Lower Thames Crossing 9.73 Tunnel Depth Report

Planning Inspectorate Scheme Ref: TR010032
Examination Document Ref: TR010032/EXAM/9.73

9.73 Tunnel Depth Report

Plate 3.1 Cross-section of river showing reference design, LOD and protection zones

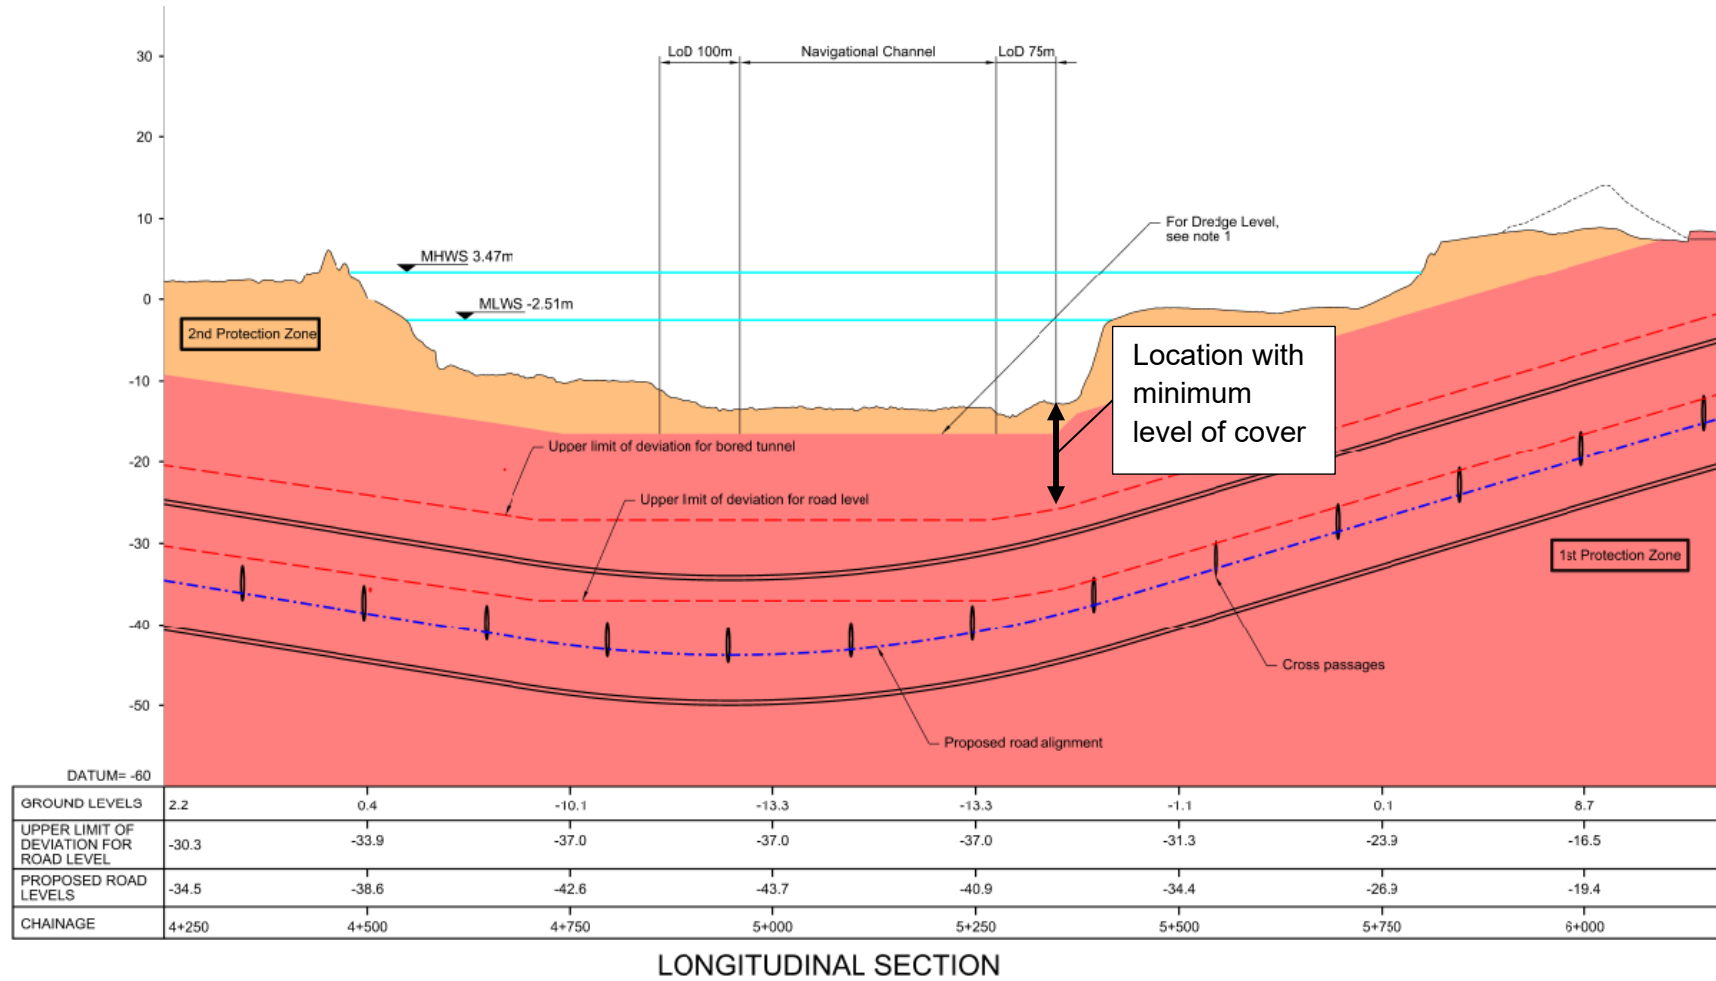
- 3.1.3 The level of cover over the tunnel is at a minimum on the northern edge of the navigable channel as shown in Plate 3.1.
- 3.1.4 At this point in the river channel, the level of cover in different scenarios is as set out in Table 3.1. These scenarios are each considered in the flotation assessment included as Appendix A.

- 3.1.5 In the most precautionary scenario (i.e. where the level of cover is at the minimum), characterised in Table 3.1 as CS6, the tunnel is constructed at the highest level allowed by the LOD while the riverbed is at its lowest level, allowing both for the lowering of the riverbed level to -16.12m above ordnance datum (AOD) by the PLA, and a further temporary reduction in level of 0.5m for the installation of scour protection. In this scenario the level of cover over the tunnel would be 9.1m, or 0.57 times the tunnel diameter (0.57D).

Plate 6.1 Illustrative cross-section showing the zone of protection and exclusion zone

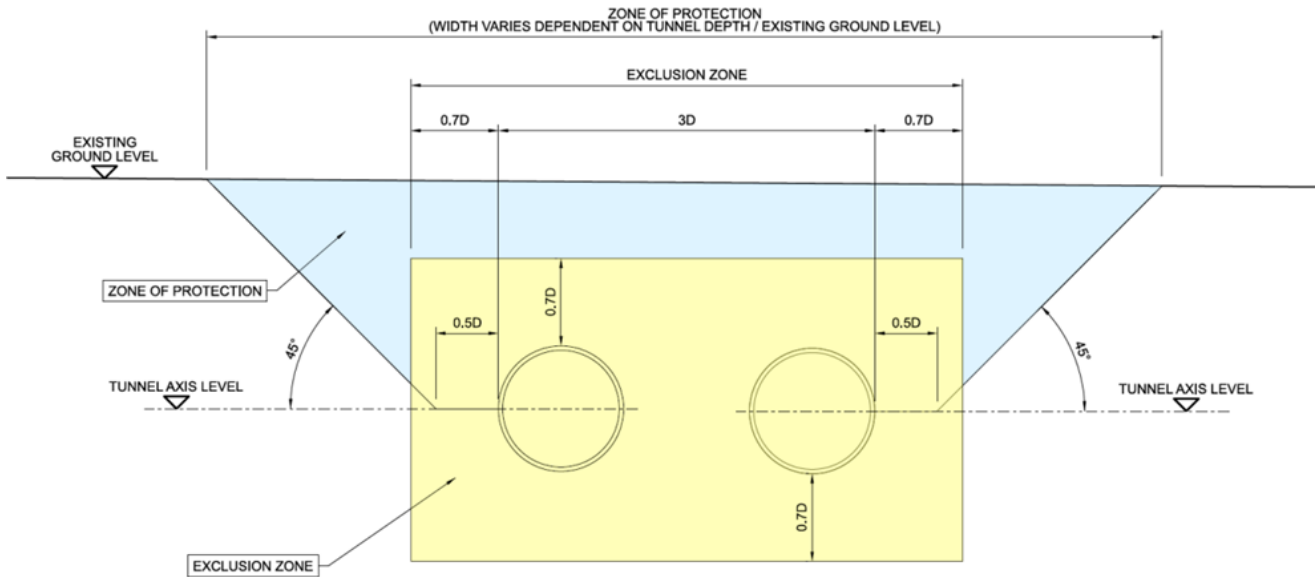
6.1.1 Section 5.4 of the Statement of Reasons [REP1-049] sets out the basis for the development of the protection zones set out in the River Restrictions Plan [REP1-041]. The basis is illustrated by Plate 6.1, which is reproduced below.

6.1.2 The Applicant acknowledges that at certain points along the tunnel profile, notably the point with minimum level of cover identified in Plate 3.1, the level of cover will be less than the 0.7D set out as the basis for the first protection zone (the exclusion zone) and that in certain locations, in the event that the riverbed is lowered, there may not be a second protection zone. The Applicant is satisfied that, considering the flotation analysis referenced in Section 4.1, and the nature of the geology in this location, that the protections and controls set out in the River Restrictions Plan [REP1-041] are robust and sufficient.

6.1.3 As the plate within the Statement of Reasons is illustrative and does not define the requirements, which are set out in the draft DCO [REP2-004] and secured documents, it is not considered necessary to update this document.
